FIG. 9
CENTRAL OFFICE TRK. CCT.
Modified to maintain Lamp Operated
During ringing cycle

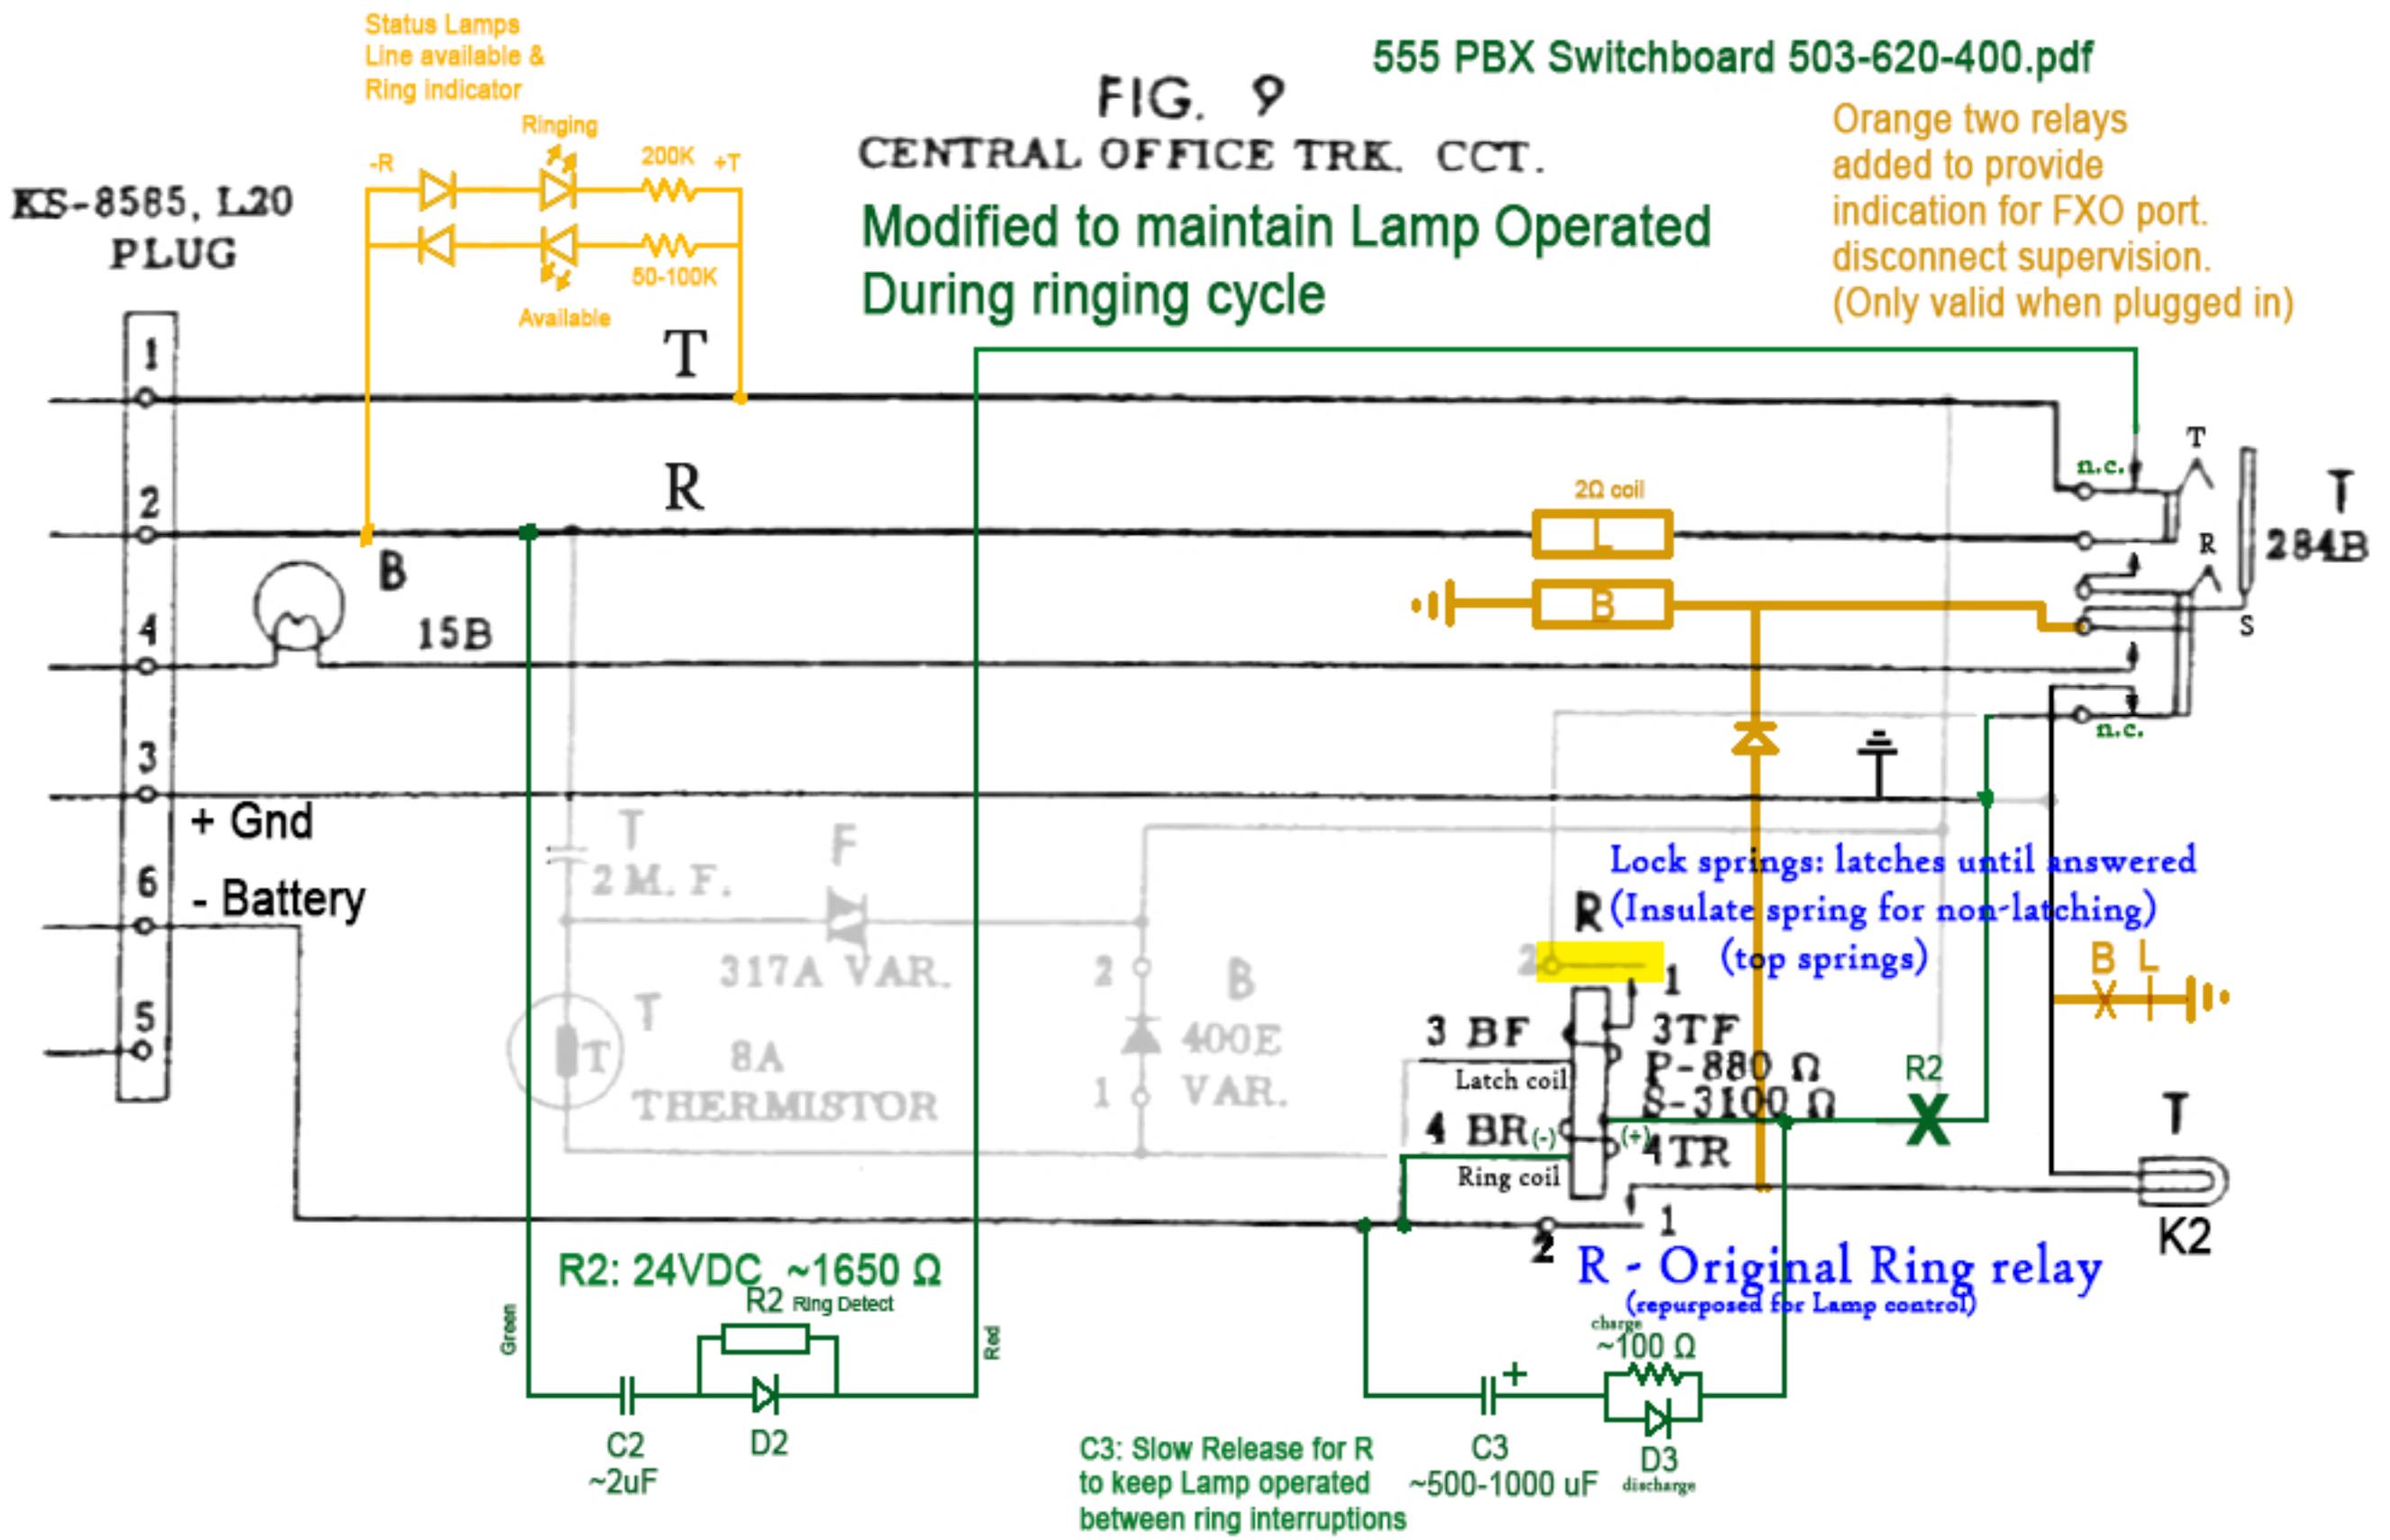
Orange two relays
added to provide
indication for FXO port.
disconnect supervision.
(Only valid when plugged in)

Lock springs: latches until answered
R (Insulate spring for non-latching)
(top springs)

R - Original Ring relay
(repurposed for Lamp control)

C3: Slow Release for R
to keep Lamp operated
between ring interruptions
